Access Compliance Report

Public Rights-of-Way

(Curb Ramps)

Intersection ID: 14977	Main Street: BUCHANAN_ST	Cross Street: KENILWORTH_AV	Location: S
ADA ID: 908E2839E4D4	Ramp Type: Perp	Initial Pass/Fail: Fail	Overall Compliance: No
Severity Score: 1.25			
Codes/Mitigation Info/Possible Solution		Field Measurements/Component Compliance

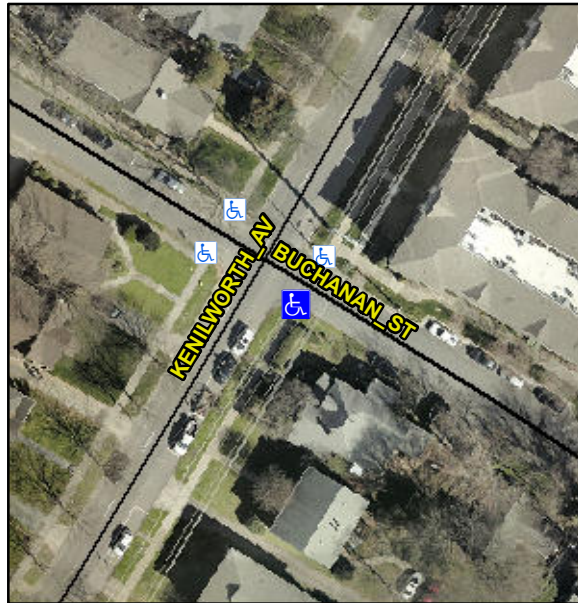
Not Found, R304.5.3

Compliance	Description	Data	Compliance	Description	Data
N/A	Ramp Length (in)	77.0	Yes	Ramp Slope (%)	5.4
Yes	Ramp Width (in)	48.0	No	Ramp XSlope (%)	4.7
N/A	Flare Type LT	N/A	N/A	Flare Type RT	N/A
N/A	Flare Slope LT (%)	N/A	N/A	Flare Slope RT (%)	N/A
N/A	Flare Traversable LT?	N/A	N/A	Flare Traversable RT?	N/A
N/A	Landing Length (in)	N/A	N/A	DWS Provided?	N/A
N/A	Landing Width (in)	N/A	N/A	DWS Contrast?	N/A
N/A	Landing Slope (%)	N/A	N/A	DWS Length (in)	N/A
N/A	Landing X Slope (%)	N/A	N/A	DWS Full Width?	N/A
N/A	Landing Curb? (Y/N)	N/A	N/A	DWS Offset (in)	N/A
N/A	Shared Landing?	N/A			
N/A	Gutter Ponding?	N/A	N/A	Gutter Slope (%)	N/A
N/A	Gutter Lip Ht (in)	1.0	N/A	Gutter X Slope (%)	N/A
N/A	Painted X Walk1?	No	N/A	Painted X Walk2?	N/A
	X Walk 1 Direction	To NE		X Walk 2 Direction	N/A
N/A	X Walk 1 Width (in)	N/A	N/A	X Walk 2 Width (in)	N/A
	X Walk 1 Slope (%)	0.3		X Walk 2 Slope (%)	N/A
	X Walk 1 X Slope (%)	3.2		X Walk 2 X Slope (%)	N/A

Remove & Replace Entire Ramp.
